STANDARDS AUSTRALIA/STANDARDS NEW ZEALAND

Amendment No. 1
to
AS/NZS 2350.4:2006
Methods of testing portland, blended and masonry cements
Part 4: Setting time

CORRECTION

SUMMARY: This Amendment applies to Figure 1.

FIGURE 1 APPARATUS FOR DETERMINING SETTING TIME OF CEMENT

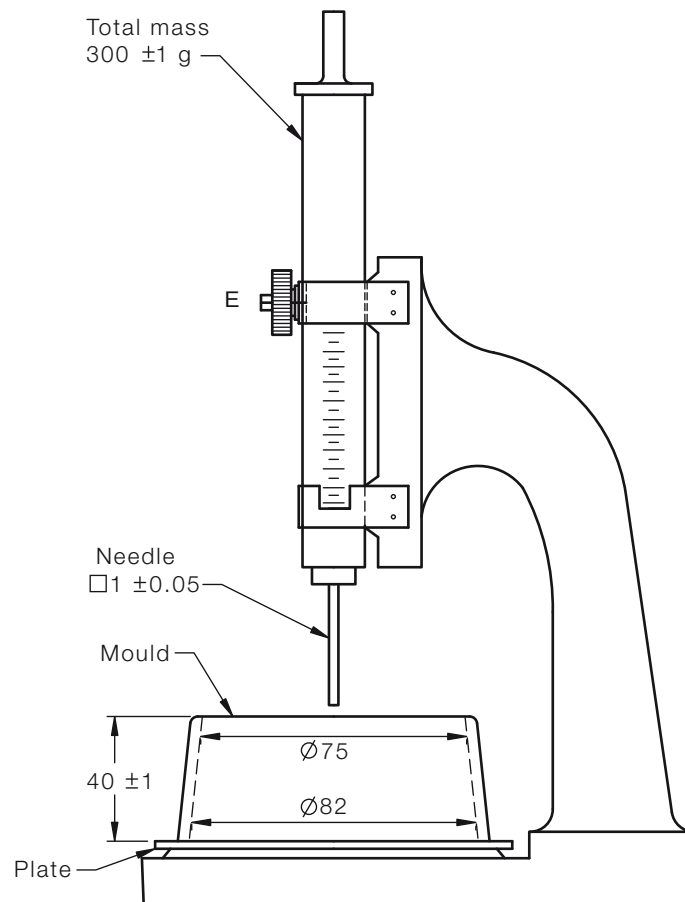
Delete existing figure and *replace* with the following (dimensions for cross-section of needle corrected):
